# Work Order ID 112203

Item ID: D3016-15 Accept \*N900040100\* Setup Start \*NS1\*  
 Revision ID: Stop \*NS2\*  
 Item Name: Gusset  
 Start Date: 2/10/14 Start Qty: 40 \*10\* Cust Item ID:  
 Required Date: 2/10/14 Req'd Qty: 10.00 \*10\* Customer:  
 Reference:

DRAWING NO. D3016	TITLE SEAT FRAME ASSEMBLY	REV. A	<b>DART AEROSPACE LTD ENGINEERING ORDER</b>	D.E.O. NO. D3016-A-1	SHEET NO. SHEET 1 OF 1	SCALE NTS
DRAWN <i>1</i>	CHECKED <i>UP</i>	MFG. APPR. <i>RE</i>	APPROVED <i>MAP</i>	DE APPR. <i>TH</i>		
DATE 10.01.29	DATE 10.01.29	DATE 10.01.29	DATE 10.01.29	DATE 10.01.29

TO REVISE D3016-11 SADDLE'S HOLE SIZES

**D3016-11 SADDLE**

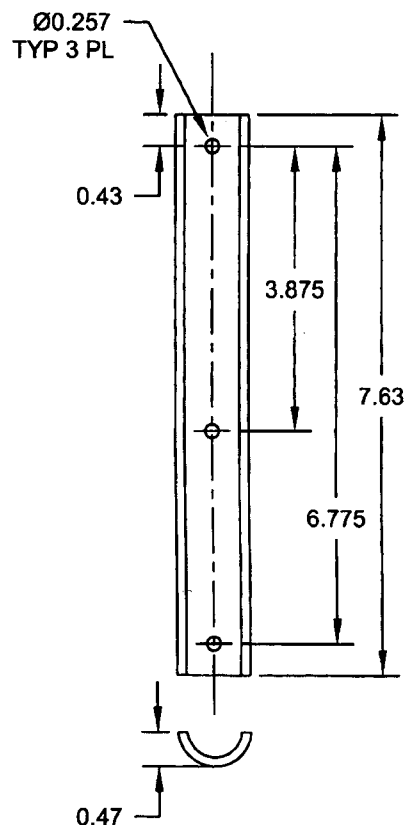
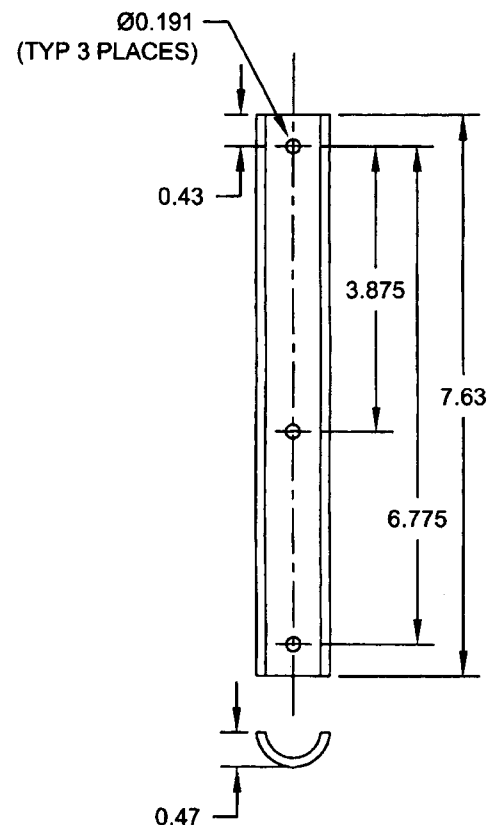
DETAIL D3016-11 SADDLE (SHEET 3): Ø0.257 TYP 3 PL WAS Ø0.191 (TYP 3 PLACES) AS SHOWN:
